Technical Service Bulletin

10 Oil is lost from the filler cap

10 21 21 2059446/4 March 8, 2021. Supersedes Technical Service Bulletin Group 10 number 20-20 dated October 29, 2020 for reasons listed below.

Figure 2. Breather line for the Supercharged V6 (EVO).

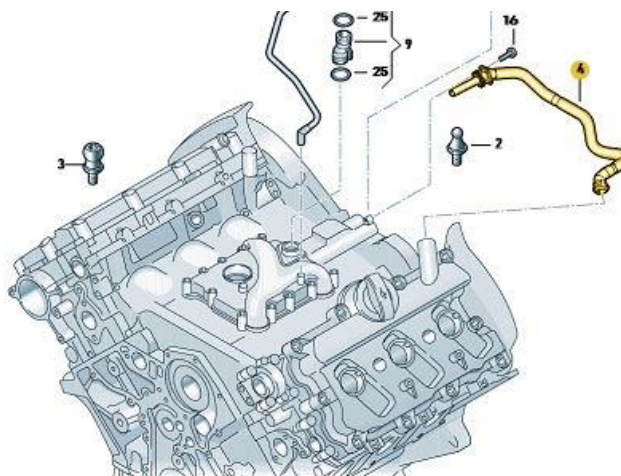
A faulty membrane in the breather line can result in excess pressure in the crankcase and therefore some oil is lost through the filler cap.

Replace the breather line (different variants available, only order by VIN) by following the Elsa repair manual (Figures 1 and 2).

A breather line with an improved membrane has been implemented in production.
